| Request           | - | Major Site Plan Review for Swayne Field Shopping Center Renovation           |
| Location          | - | 3054 Monroe Street   |

MAJOR SITE PLAN REVIEW  
TOLEDO PLAN COMMISSION  
REF: SPR25-0016  
DATE: July 3, 2025  
TIME: 2:00 P.M.

**C200**

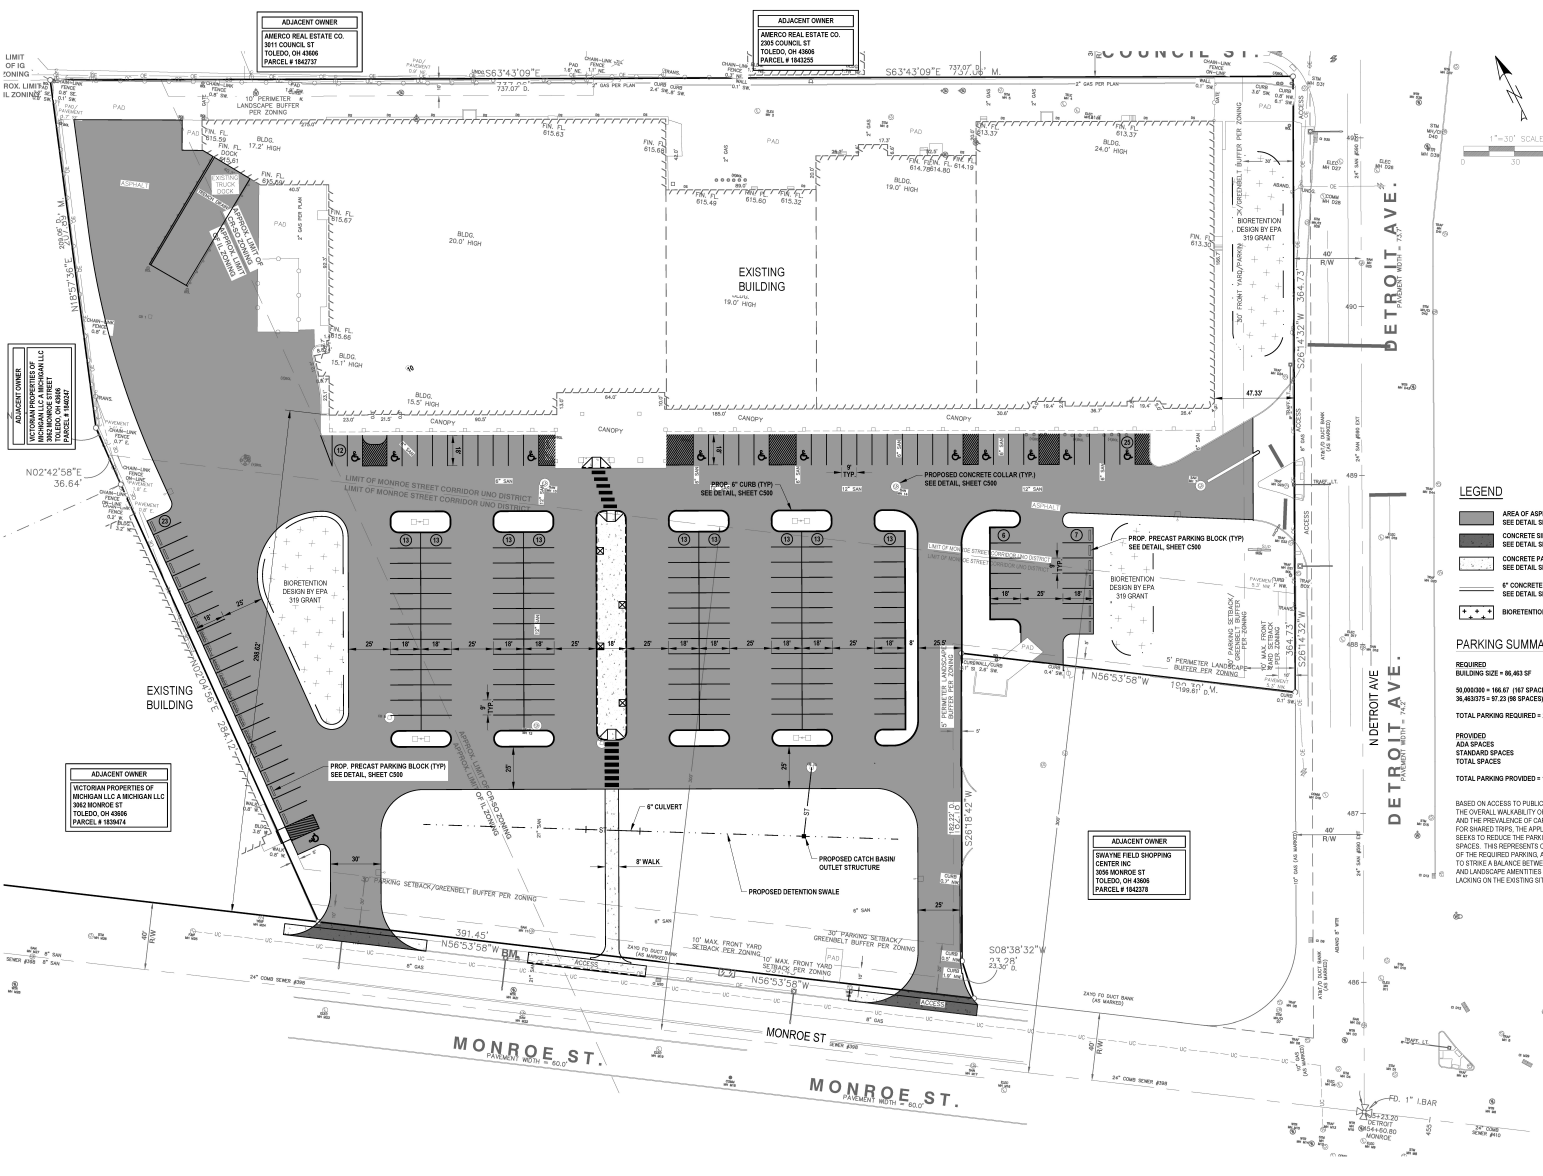
TMC§1109.0304 *Pedestrian Circulation* requires that continuous internal pedestrian connecting walkways be provided from each primary street frontage to the principal customer entrance of each principal building. The proposed walkway to Monroe Street meets this requirement; however, a walkway to Detroit Avenue is not shown. The applicant has indicated that they plan to install this walkway. A revised site plan shall be submitted to the Plan Director depicting a pedestrian walkway connecting the walkway along the front of the building to the public sidewalk along Detroit Avenue. This has been included as a condition of approval.

22. One (1) bicycle parking space is required per ten (10) vehicle parking spaces. Bicycle parking spaces shall be compliant with TMC§1107.0900. **Not acceptable as depicted. A revised site plan shall be submitted to the Planning Director depicting a minimum of nineteen (19) bicycle parking spaces.**

24. A hedge row or masonry wall shall be installed between Detroit Avenue and the bioretention area depicted on the site plan so that no headlights of any vehicles can be seen from the public street. **Not acceptable as depicted. A revised site plan shall be submitted to the Planning Director.**

31. A continuous internal pedestrian connecting walkway is required between Detroit Avenue and the walkway along the front of the principal building in compliance with TMC§1109.0304. **A revised site plan shall be submitted to the Planning Director depicting this walkway.**

# LANDSCAPE PLAN

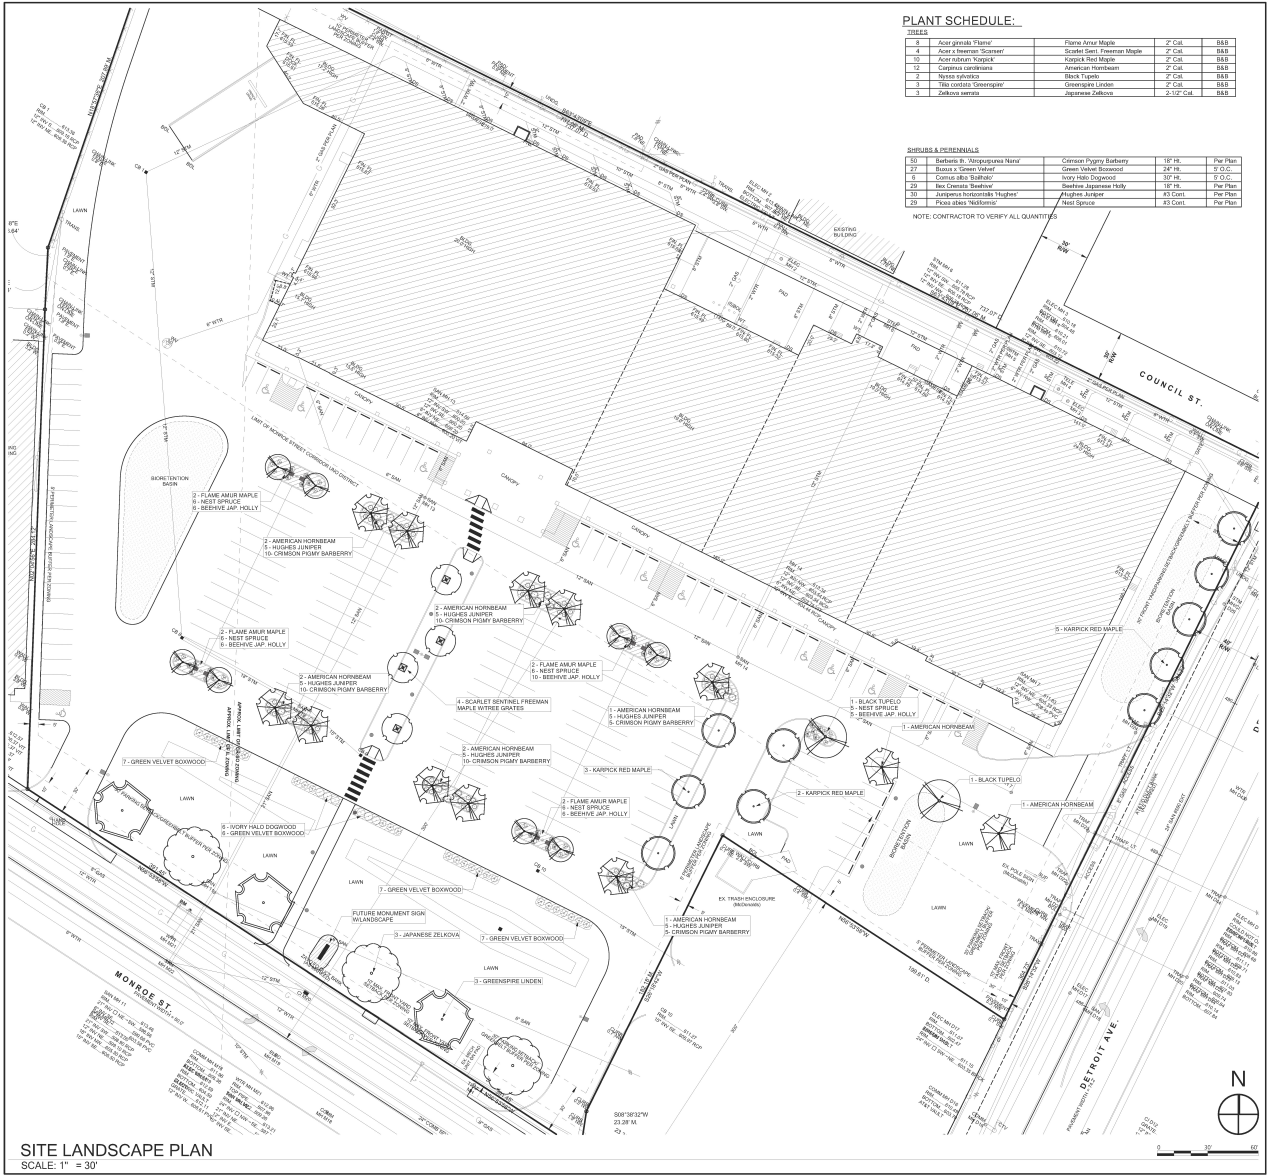
TMC§1108.0202 *Frontage Greenbelt* requires landscaped greenbelts along public rights-of-way. At least one (1) tree would be required within this greenbelt for every thirty feet (30’) of lot frontage. TMC§1108.0202 would require thirteen (13) trees in the Monroe Street greenbelt. The applicant has provided six (6) trees on the submitted landscape plan and asked that this reduced number of trees be permitted due to limited planting areas and to allow greater storefront visibility. The Planning Director has determined that this is acceptable due to the characteristics of the proposed improvements.

TMC§1108.0202 would also require thirteen (13) trees along the Detroit Avenue greenbelt. The applicant has provided five (5) trees on the submitted landscape plan and asked that this reduced number of trees be permitted due to existing driveways and the existing McDonald’s sign. The Planning Director has determined that this is acceptable due to the characteristics of the proposed improvements.

TMC§1108.0202 also requires frontage greenbelts to include a solid evergreen hedge planting to screen parking lots so that no headlights of any vehicles can be seen from the public street whenever a parking lot is in the front of the property. The submitted landscape plan provides the hedge plantings along Monroe Street, but not along Detroit Avenue. The applicant asked that this be permitted due to a bioretention area which requires sheet flow from the parking area to a bioretention area. Staff agrees that a shrub row between these areas would disrupt sheet flow and be harmful to the plantings; however, Staff also believes that a hedge row or masonry wall could be installed between the bioretention area and the street. This has been included as a condition of approval.

Based on the number of proposed parking spaces, TMC§1108.0204 *Parking lot Landscaping* would require the parking area to include 3,800 square feet of landscaped area with a minimum of thirty-eight (38) trees and one-hundred-fourteen (114) shrubs. The submitted landscape plan provides 3,984 square feet of landscaped area with thirty-one (31) trees and one-hundred-thirty-eight (138) shrubs. The Planning Director has determined that this is acceptable due to the characteristics of the proposed improvements.

Based upon the size of the building, TMC§1108.0205 *Interior Site Landscaping* would require that the site include eighty-six (86) trees on top of other landscaping requirements along with foundation plantings. No additional trees or foundation plantings are proposed on the submitted site plan. The Planning Director has determined that this is acceptable due to the characteristics of the proposed improvements.

TMC§1108.0406 *Irrigation/Watering* requires landscaped areas to be irrigated to maintain required plant materials in good and healthy condition. Water outlets (hose bibbs) are required within 100 feet of all required plant material unless a subsurface irrigation system is used. Plantings may be further than 100 feet from water outlets in areas where sufficient xeriscaping is used. This requirement is imposed on all landscaped areas whether they fall under TMC§§ 1108.0200 or 1108.0300. The applicant is seeking a variance from this requirement; however, they may be able to comply with the section if they submit a xeriscaping plan in lieu of artificial irrigation. Such a xeriscaping plan would need to contain a watering plan during plant establishment (approximately three years) and detailed depictions of xeriscaping features and techniques used, including soil type, drainage, topography, and plant cultivars/native plants. Compliance with TMC§1108.0406 shall be included as a condition of approval – whether that be through artificial means (hose bibbs) or an acceptable xeriscaping plan.

25. Landscaped areas must be irrigated as necessary to maintain required plant materials in good and healthy condition per TMC§1108.0406. Compliance with this condition may be achieved through any method prescribed by TMC§1108.0406. If xeriscaping is used, a xeriscaping plan must be submitted to the Planning Director for review and approval.
